# Access Compliance Report

## Public Rights-of-Way

### (Curb Ramps)

Intersection ID: 6957	Main Street: N_TRYON_ST	Cross Street: N_US_29_BY-PASS_HY	Location: W
ADA ID: 241424FBE7C6	Ramp Type: Perp	Initial Pass/Fail: Fail	Overall Compliance: No
Severity Score: 12.5			
Codes/Mitigation Info/Possible Solution		Field Measurements/Component Compliance

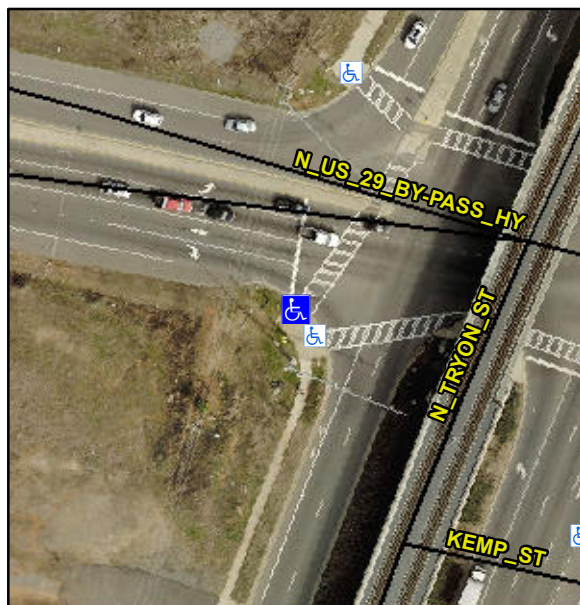
**Remove & Replace Entire Ramp.**

**Not Found, R304.2.2**

Compliance	Description	Data	Compliance	Description	Data
N/A	Ramp Length (in)	96.0	No	Ramp Slope (%)	8.9
Yes	Ramp Width (in)	48.0	Yes	Ramp XSlope (%)	1.7
N/A	Flare Type LT	N/A	N/A	Flare Type RT	N/A
N/A	Flare Slope LT (%)	N/A	N/A	Flare Slope RT (%)	N/A
N/A	Flare Traversable LT?	N/A	N/A	Flare Traversable RT?	N/A
N/A	Landing Length (in)	N/A	N/A	DWS Provided?	N/A
N/A	Landing Width (in)	N/A	N/A	DWS Contrast?	N/A
N/A	Landing Slope (%)	N/A	N/A	DWS Length (in)	N/A
N/A	Landing X Slope (%)	N/A	N/A	DWS Full Width?	N/A
N/A	Landing Curb? (Y/N)	N/A	N/A	DWS Offset (in)	N/A
N/A	Shared Landing?	N/A			
N/A	Gutter Ponding?	Yes	N/A	Gutter Slope (%)	N/A
N/A	Gutter Lip Ht (in)	N/A	N/A	Gutter X Slope (%)	N/A
N/A	Painted X Walk1?	Yes	N/A	Painted X Walk2?	N/A
	X Walk 1 Direction	To NE		X Walk 2 Direction	N/A
N/A	X Walk 1 Width (in)	110.0	N/A	X Walk 2 Width (in)	N/A
	X Walk 1 Slope (%)	0.4		X Walk 2 Slope (%)	N/A
	X Walk 1 X Slope (%)	1.0		X Walk 2 X Slope (%)	N/A
